Private Plan Change Request
74 (PC74)

**STATEMENT OF EVIDENCE OF HUGH ANTHONY NICHOLSON
ON BEHALF OF SELWYN DISTRICT COUNCIL**

URBAN DESIGN AND LANDSCAPE

28 November 2022

Figure 3: Revised ODP showing connections to Rossington Drive, Halkett Road and SH73.

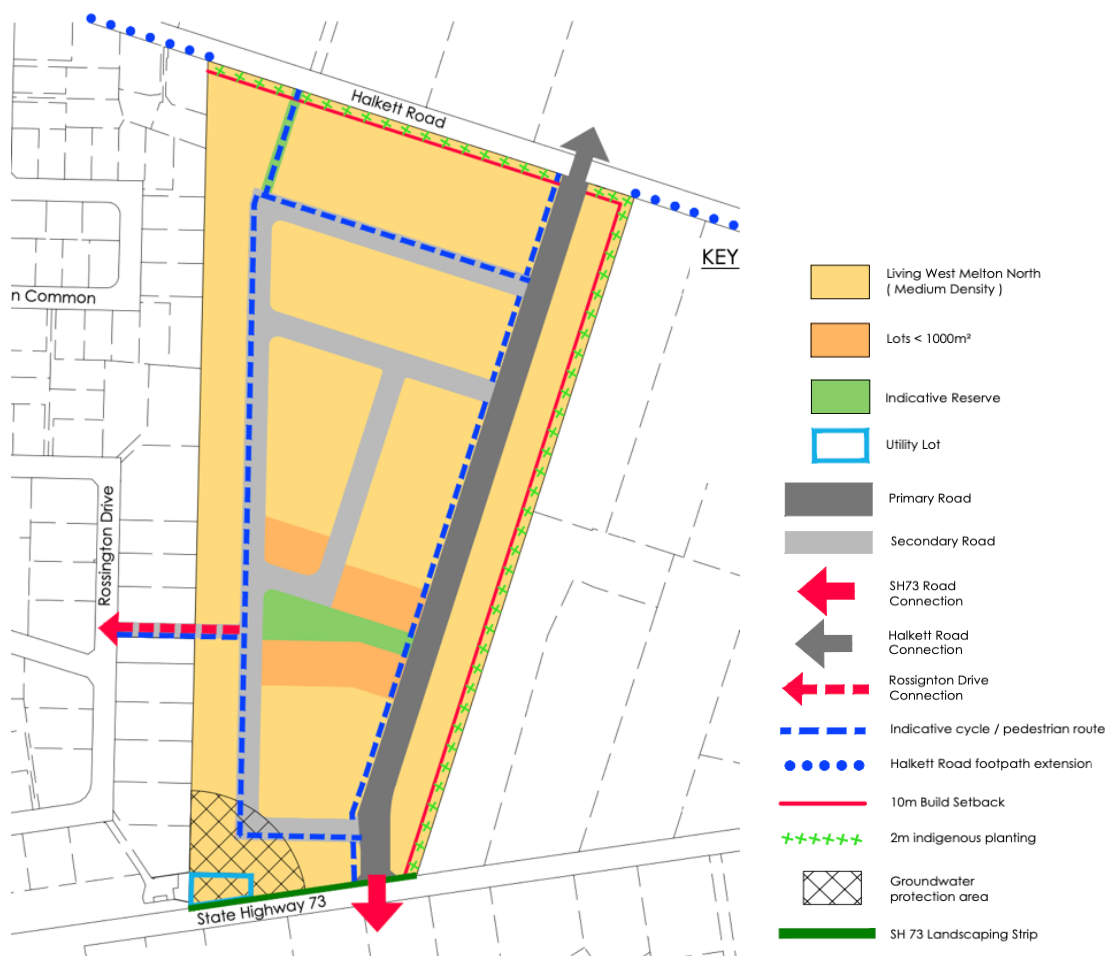
- 7.2 The revised ODP provides three connections, one northward onto Halkett Road, one southward onto SH73, and one westward onto Rossington Drive.
- 7.3 The revised ODP also identifies that the Halkett Road frontage will be upgraded to an urban standard and footpath extensions will be provided to the east to Wylies Road and to the west to Rossington Drive. No frontage upgrade to an urban standard is noted for the SH73 frontage, nor is a footpath extension to the pedestrian crossing point to the west identified.
- 7.4 I consider that if a future street connection could be provided to the east, and an urban upgrade to the SH73 frontage with a footpath extension to the west to the existing crossing facility, could be included in the ODP, the site could have a *moderate* level of connectivity.

- a. Include land for a future street connection to the east;
- b. Specify an urban upgrade to the SH73 frontage with a footpath extension to the west to the existing crossing facility in the ODP narrative;
- c. Specify a minimum density of 12hh/ha in the ODP narrative;
- d. Include a requirement to provide post and rail fences along the northern and southern boundaries in the ODP narrative.
